DRAFT REPORT
TO THE
BOARD OF NATURAL RESOURCES & CONSERVATION
ON THE
BONNEVILLE POWER ADMINISTRATION'S
500 KILOVOLT TRANSMISSION LINE
FROM TOWNSEND - GARRISON, MONTANA

AN ADDENDUM TO THE FEDERAL COLSTRIP PROJECT EIS

Department of Natural Resources and Conservation
April 1982

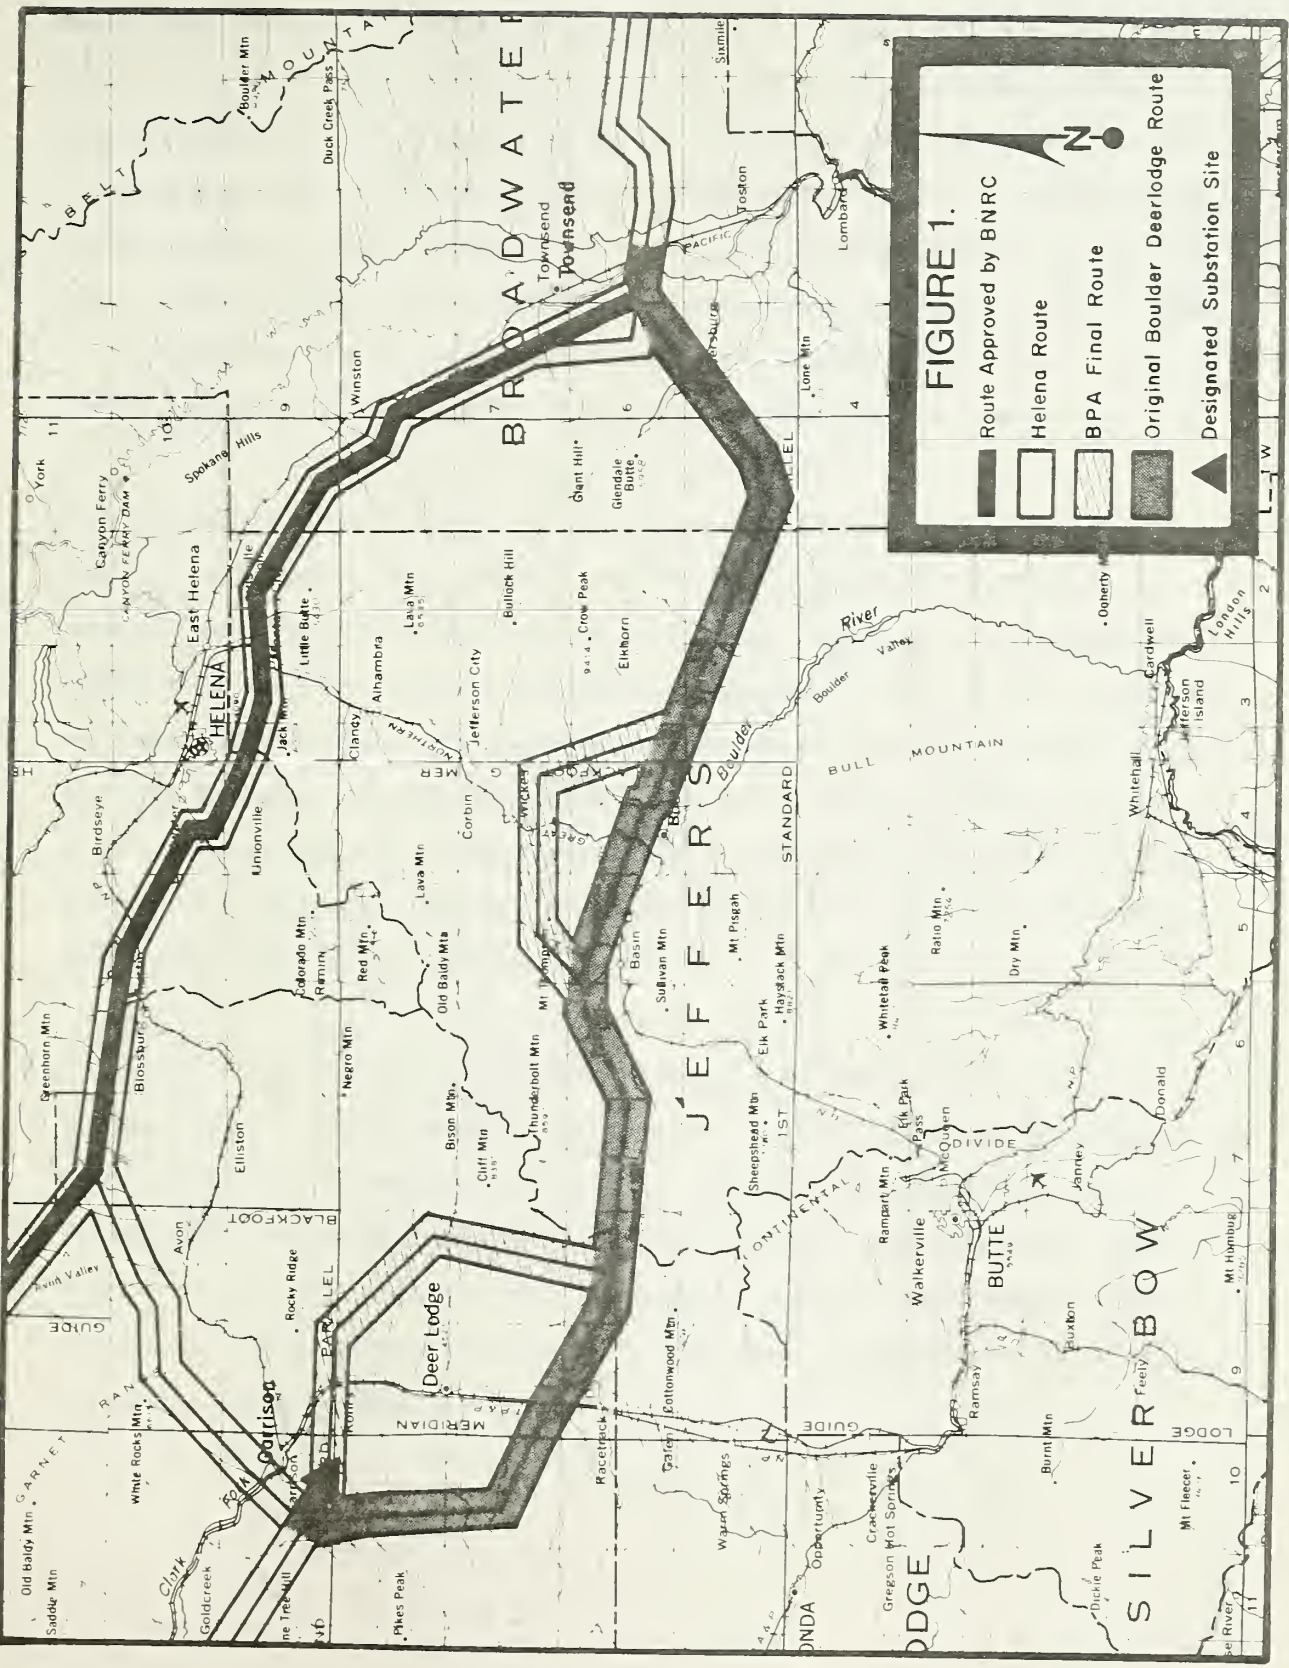
This section evaluates the alternative routes shown in Figure 1. These routes are referred to as the Helena Route, the Original Boulder-Deer Lodge Route (Original BDL Route) and the BPA Final Route. The Helena Route is identical to the route approved by the Board from Townsend to the Blossburg area west of the Continental Divide. From Blossburg to Garrison the route was generated by the federal agencies. The Original BDL Route was the preferred route selected by the federal agencies in their September 1979 Record of Decision (ROD) from all the alternatives they considered between Townsend and Garrison. The BPA Final Route was selected in the August 1981 ROD in response to public concerns and problems with the Original BDL Route.

This table is based entirely on numerical impact scores from the federal documents. The BPA Final Route, which was ultimately selected, ranks worst for 7 of the 12 determinants and is also worse in terms of total impact scores. It ranks best for only one determinant, agricultural land. Strong public concerns about

impact to agricultural land are reflected in this determinant. Based on this same table, the Original Boulder-Deer Lodge Route ranks best overall and is also best for 7 of the 12 determinants. It ranks worst for none. In arriving at a final decision on the Townsend-Garrison route, the Record of Decision indicated that the concerns of residents and landowners along the Original BDL Route -- especially visual concerns -- were given a high weight. However, according to Table 1, visual impact for the BPA Final Route was worse than that of either the Original Boulder-Deer Lodge Route or the Helena Route.

For example, one of the major reasons for the Boulder area reroute (the BPA Final Route) was the fact that the Original BDL Route crossed 1.7 miles of irrigated land in the Boulder Valley (USDI 1981b, Table 1). However, it is possible that a centerline could have been found which actually crossed less irrigated cropland and did not interfere with irrigation systems. This cannot be determined from available data. Second, the amount of land actually taken out of production by the tower bases is small, amounting to about 0.15 acres of irrigated cropland (USDI 1978, p. VII-100). Finally, interference with existing irrigation systems, if any, could possibly be mitigated by careful placement of towers and/or modification of existing irrigation systems so that there would be little or no net loss of irrigated acreage (Varner and Patel 1982; Henderson and Scott 1981; and Malefyt 1981). At worst, the TER estimates crop value loss for the entire Original BDL Route to be on the order of \$750-\$1500/yr (USDI 1978, p. VII-58). In comparison, line losses of electricity for the BPA Final Route are about \$700,000 greater over the life of the facility than those of the Original BDL Route, and construction costs would be about \$900,000 greater (USDI 1981b, Table 4). A yearly cost was not given for line losses.

FIGURE 2.

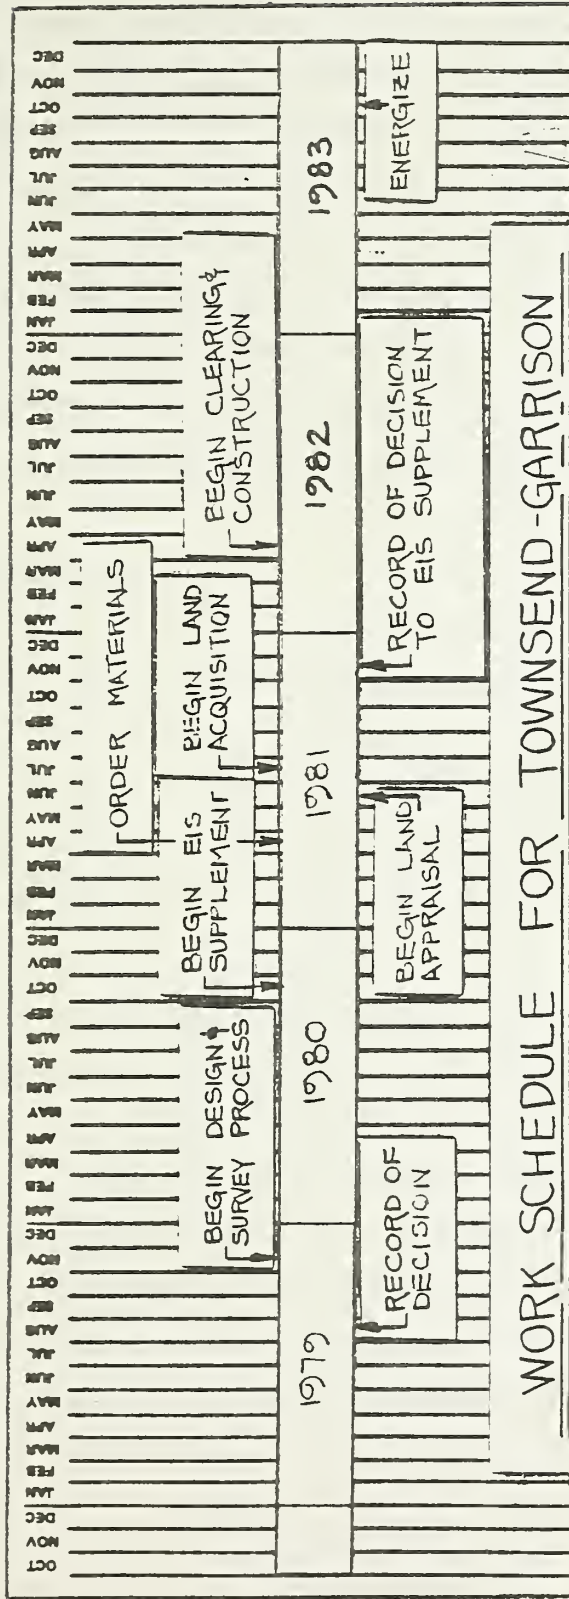
The relationship between a delay in starting construction of the transmission lines and the time of completion is not clear. BPA indicates the current schedule is extremely tight and there are no significant possibilities for shortening the schedule (see Appendix B). DNRC was unable to identify any measures which would be effective in significantly reducing the construction schedule, other than possibly adding more and smaller segments to the construction plan, for example having six, or nine simultaneous construction spreads instead of the three that are planned. BPA does not believe that this could be done effectively. If the schedule cannot be shortened, or if a delay in the starting date pushes construction activities into the winter season of late 1983, there is the possibility that completion might be delayed until the spring of 1984, with commercial operation of Colstrip 3 then delayed until the summer of 1984.
